Turbo HD DVR V4.84.010build251031 Release Notes

Reason of Upgrade

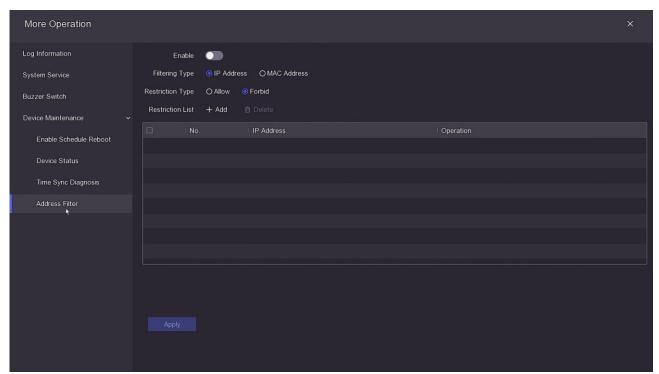
1. Support co-branding function on HPP platform

- a. The HPP platform supports replacing the DVR startup LOGO and live view screen LOGO with the installer's LOGO:
- b. Scope of device models:72HQ/HU/HT-M/XT, 72HU-M/PXT, 71/72HQ-M/T, 72HU-M/T, 71HQ-M/S, 72HQ-M/E;

Web:

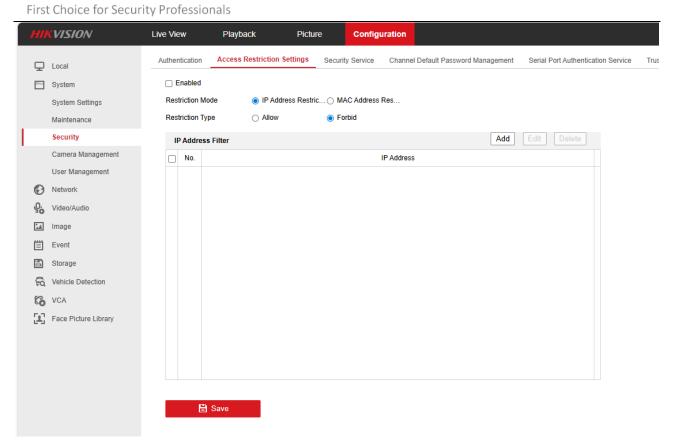
2. Support IP or MAC address whitelist and blacklist filtering function.

- a. Local/WEB supports IP or MAC address black and white list filtering function;
- b. Scope of device models: 72HQ/HU/HT-M/XT, 72HU-M/PXT, 71/72HQ-M/T, 72HU-M/T, 71HQ-M/S, 72HQ-M/E
